Appearance Commission - CANCELLED

APPLICANT	Edward Davies on behalf of Target
ACTION REQUESTED	Approval of landscape plan
ADDRESS	17605 Halsted
PIN	29-33-100-064-0000

PRELIMINARY SITE/LANDSCAPE PLAN REVIEW

T1460 Homewood Appearance Commission Materials
Target Front Walk and Exterior Site Sustainability Program

FW EXISTING CONDITIONS - DEMO PLAN

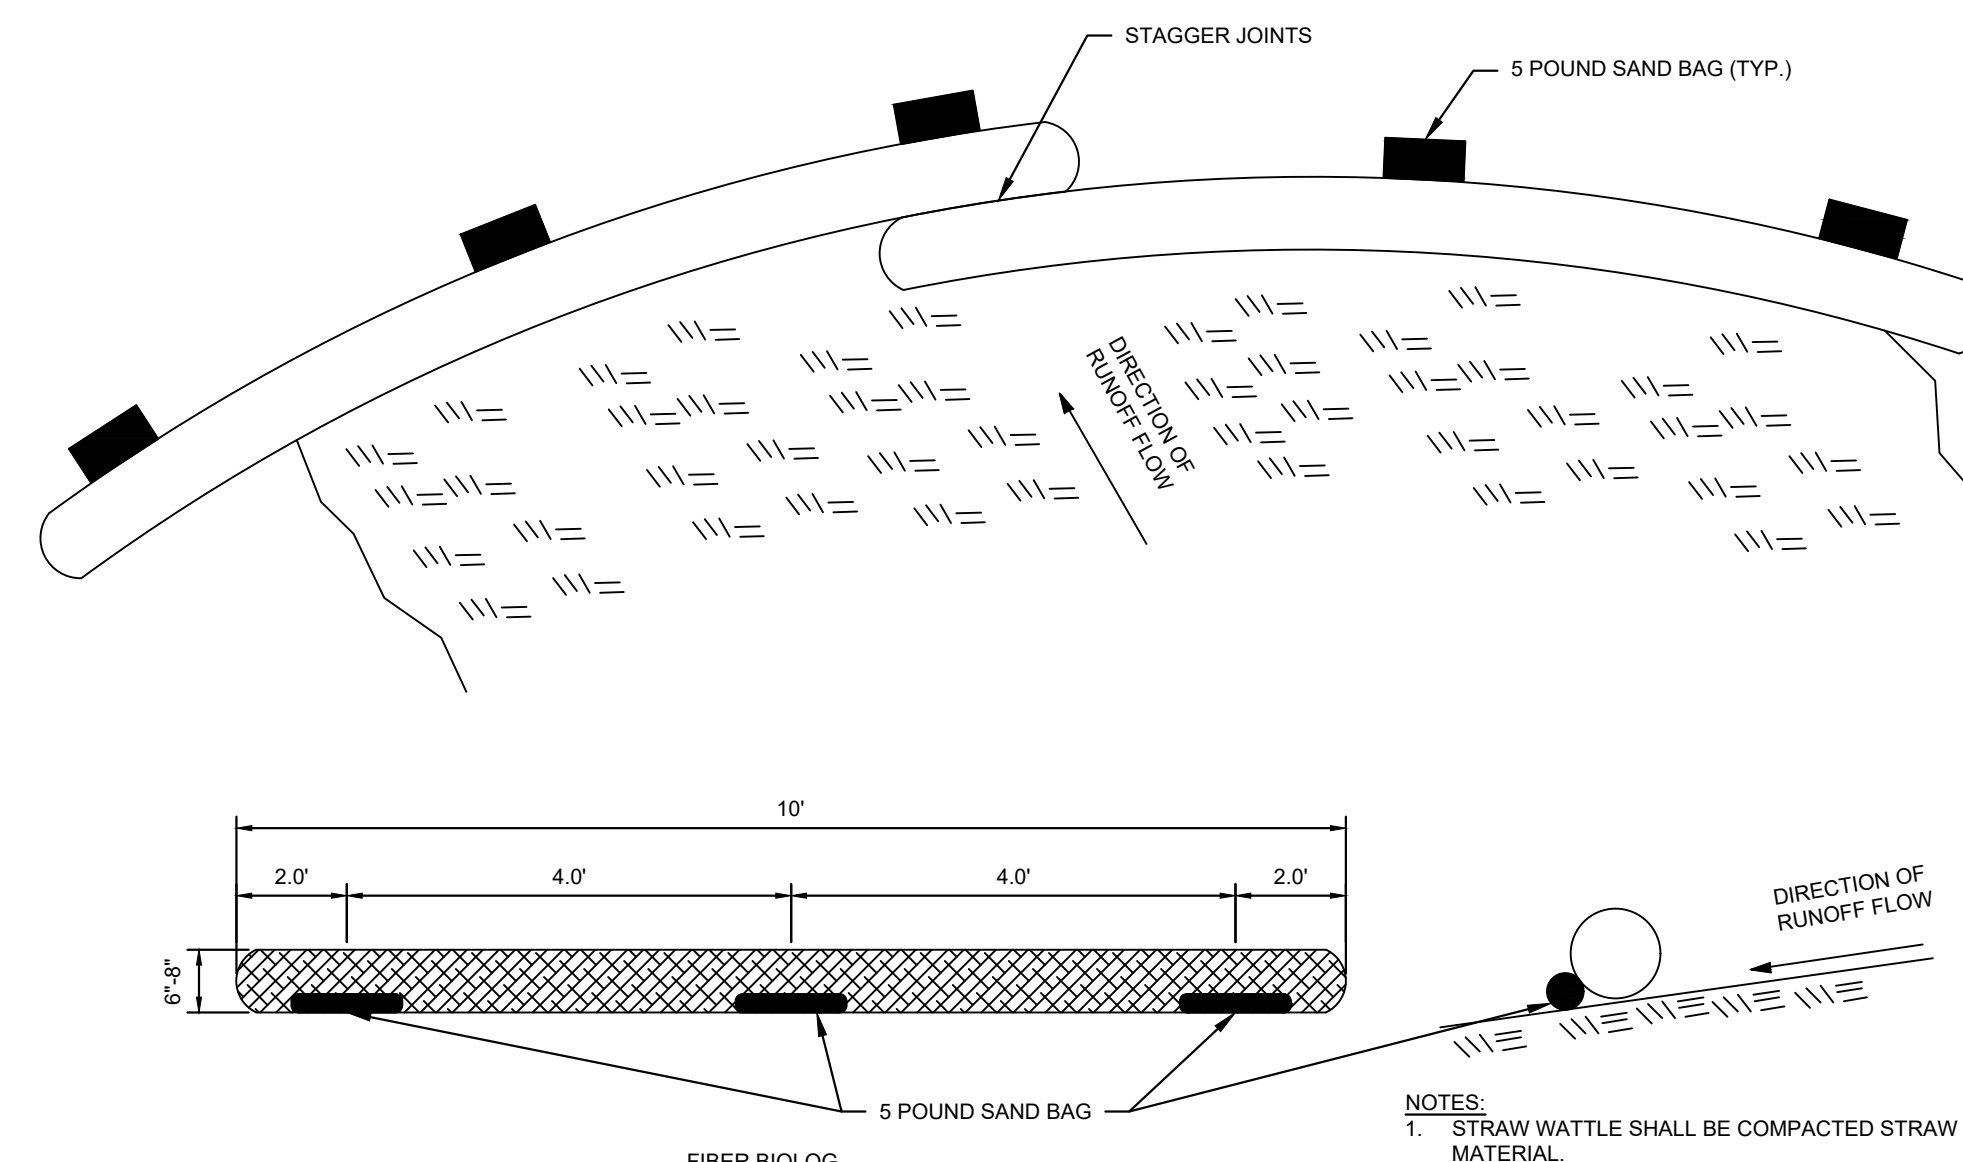
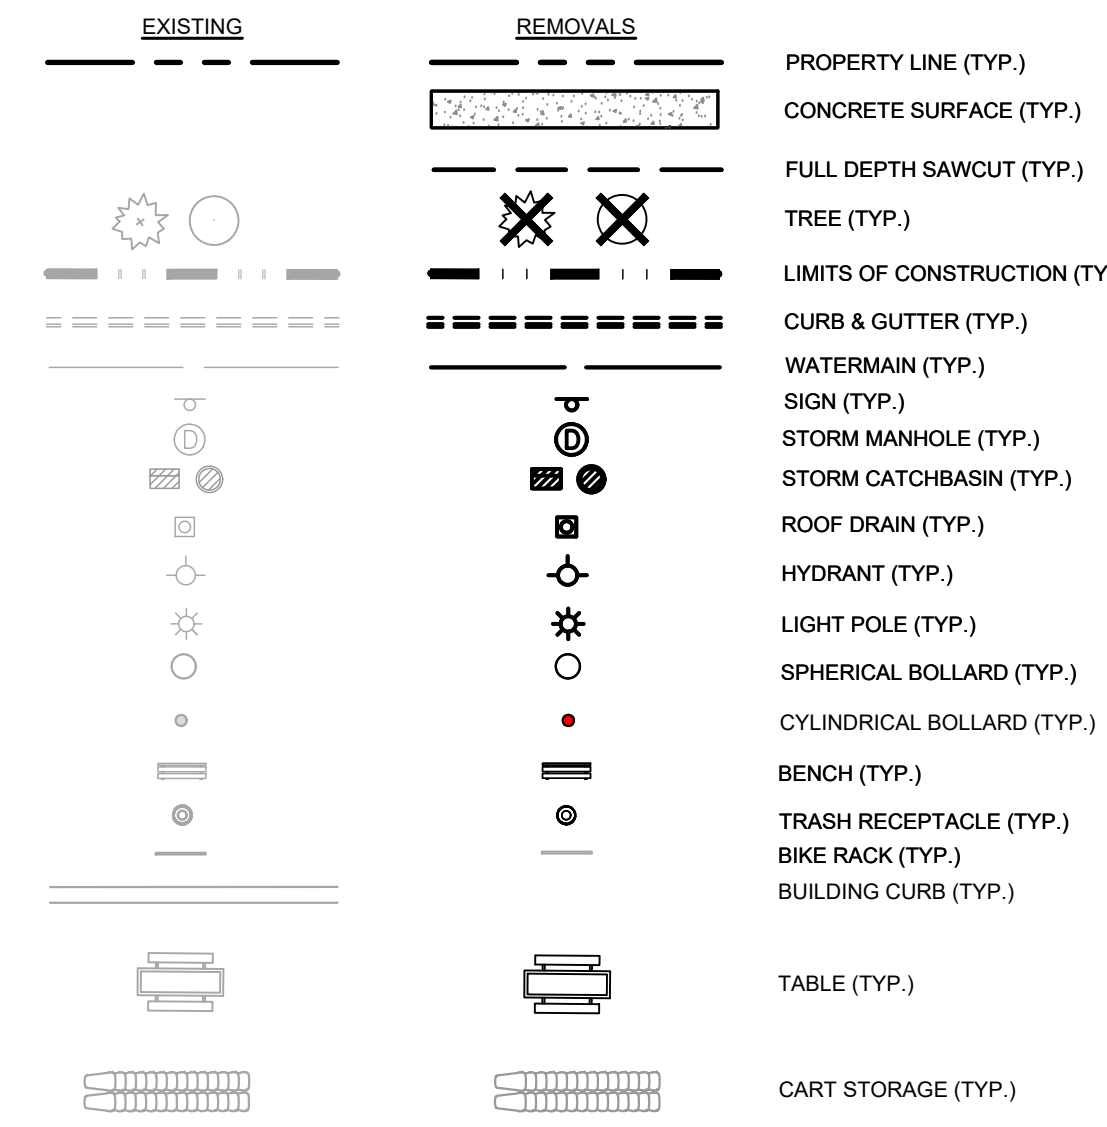
14. Coordinate the civil and engineering sheets. Sheet C200 shows benches and trash receptacle at the store in a line weight indicating new work. Sheet L101 calls for these site furnishings to be removed. Indicate areas of new work at the walkway on C200.
15. Title of sheet C200 is misspelled.
16. Bicycle racks should be installed in accordance with the NACTO or APBP standards. Provide dimensions demonstrating compliance with these best practices.

XSS LANDSCAPE PLAN

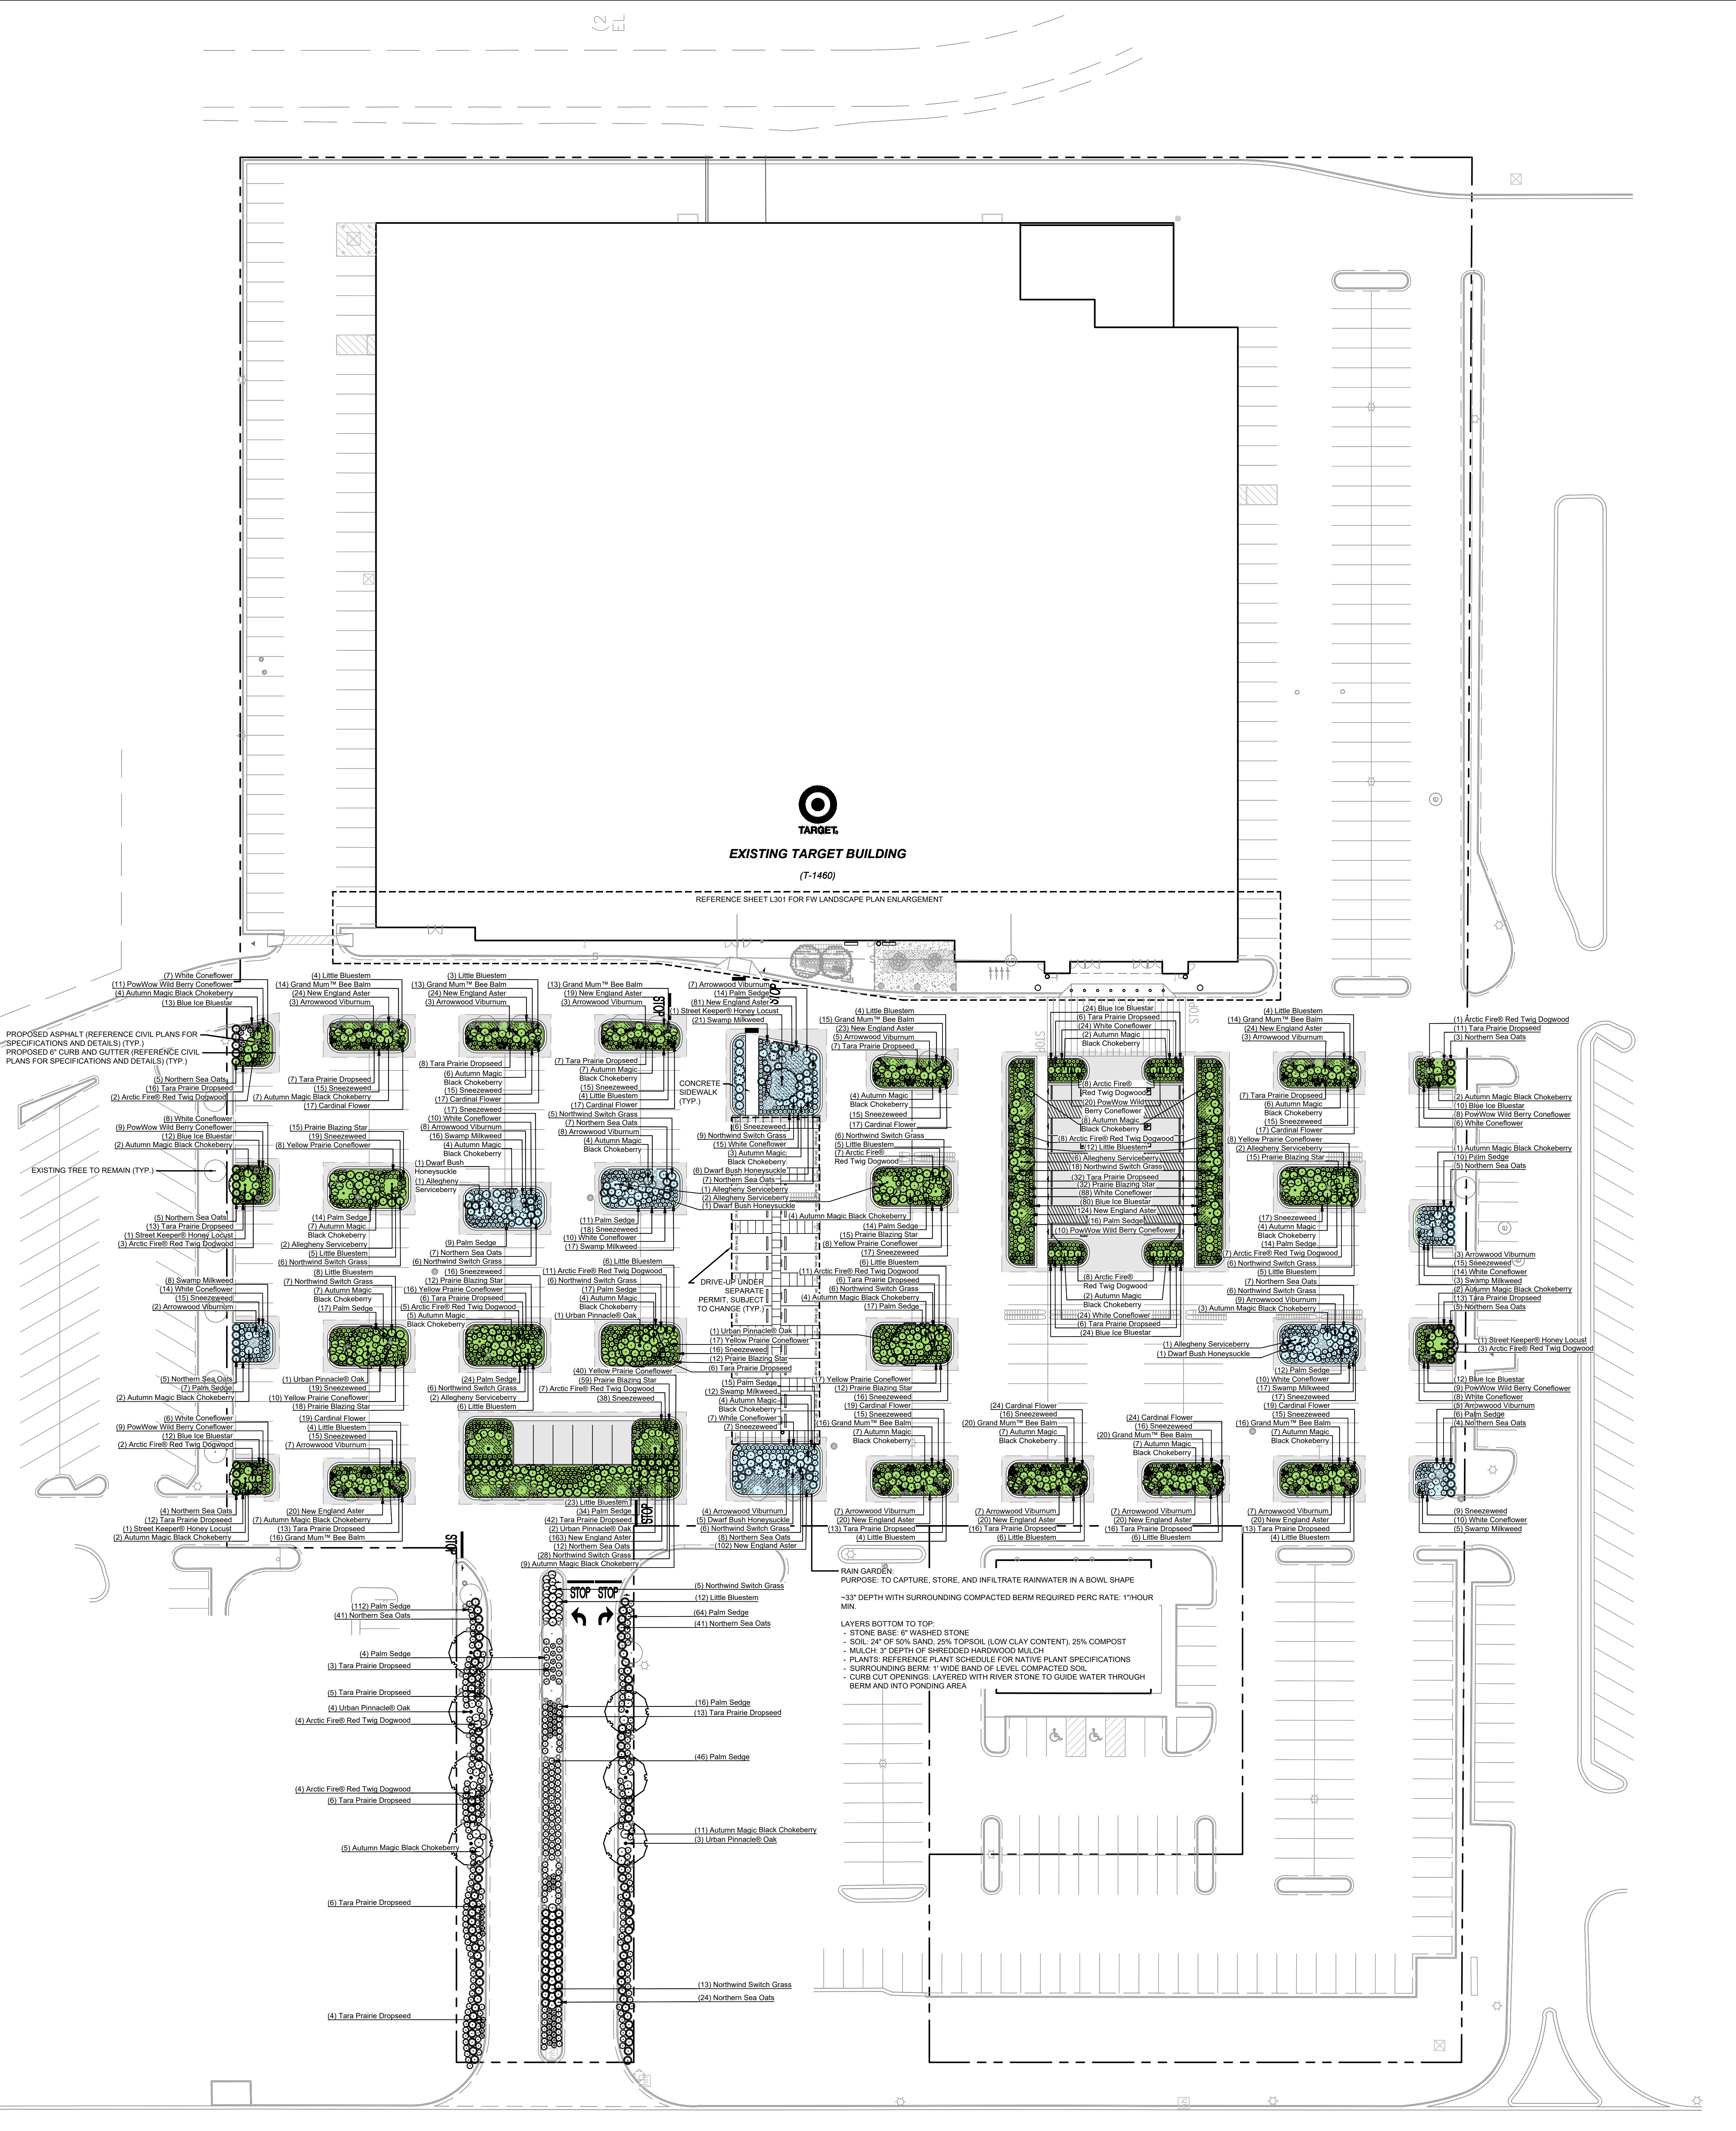
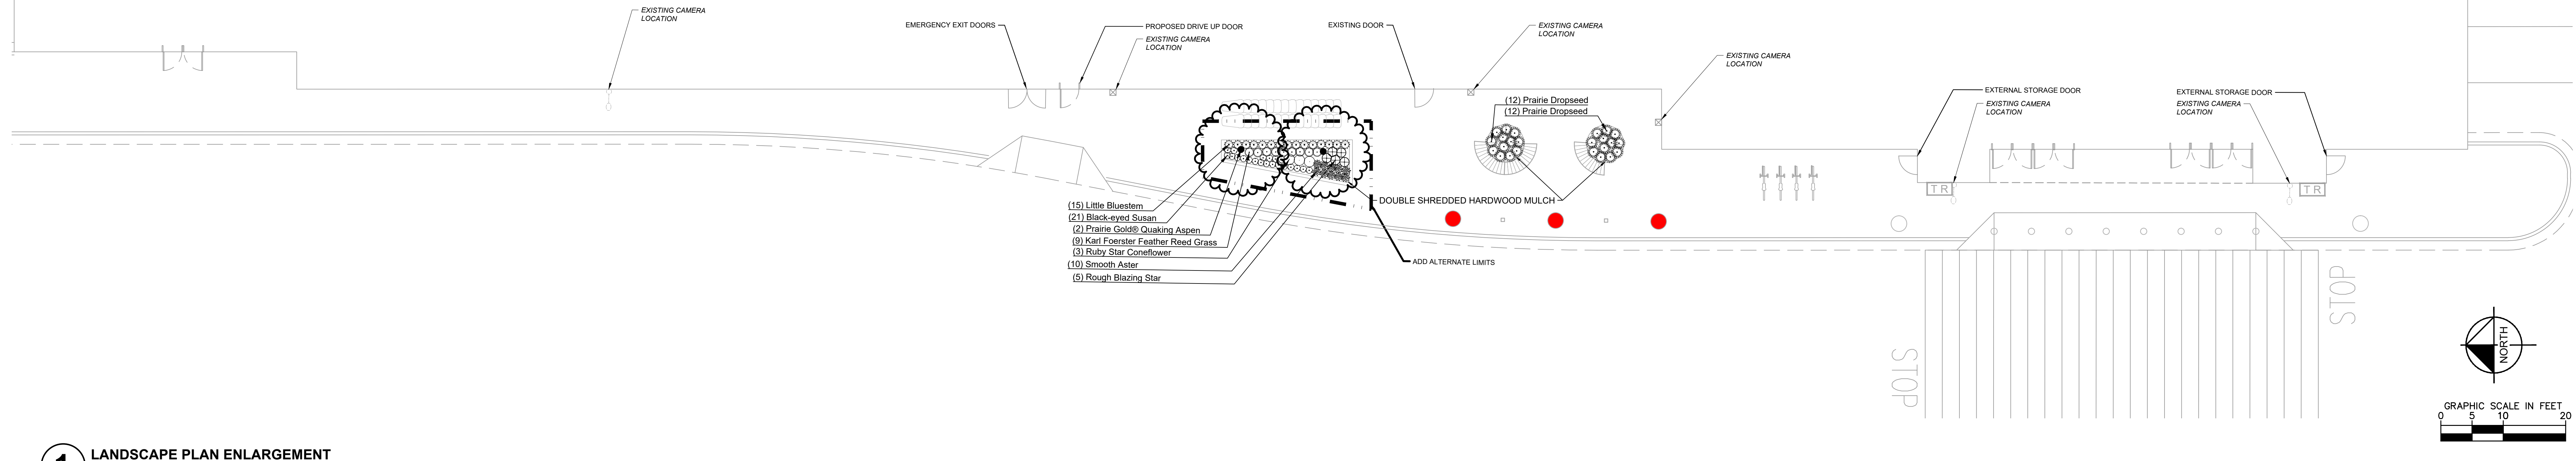
The plans indicate 8 different planting beds as "rain gardens." All except for one are co-located at existing storm sewer inlets. The plants selected for the "rain gardens" are pollinator plants and not plants with a functional performance for a rain garden or bioswale. Staff has requested more details about the intended function of the areas denoted as "rain gardens," specifically addressing how the property owner will keep heavy rains from carrying mulch, soil, or plant materials into the catch basin and clogging the inlet; and how the landscape beds are anticipated to function as rain gardens.

8. There appears to be one “rain garden” planting bed that does not encompass an inlet and has no curb openings to collect water from the surrounding pavement. Provide more information about how this will function.

FW IRRIGATION PLAN

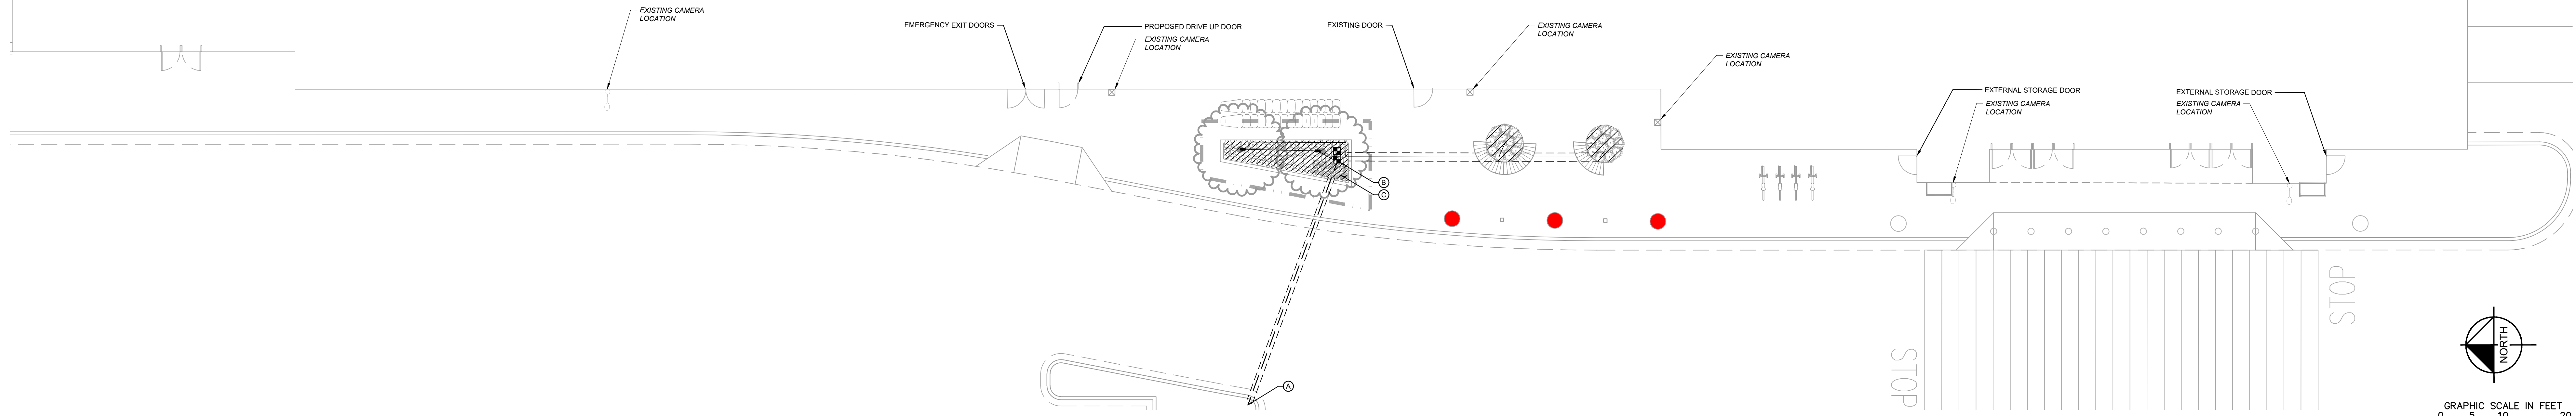
The submitted plans indicate irrigation only to the planting beds in the front walkway. The Village Arborist has noted that the parking lot planting beds will need water in the summertime. Staff would like to know more about how the property owner intends to maintain the site landscaping over time.

10. All plants will need watering in the summer time. The irrigation plan indicates only the planters in the walkway to be irrigated. How will the remaining 19,000 sf of new landscaping be maintained?
11. Please refer to ANSI A300, ANSI Z133.1 and ISA Best Management Practices to comply with the Village of Homewood requirements.
12. What are the plans for snow removal? Stock piling snow on the landscape beds deposits salt into the landscape beds, drying out the soil and contributing to the decline of the plant health.
13. The plants specified for the areas identified as “rain gardens” are not bio-swale plants that tolerate nor absorb standing water. Rather, they are pollinator plants. Please clarify how the areas designated as “rain gardens” are intended to function.
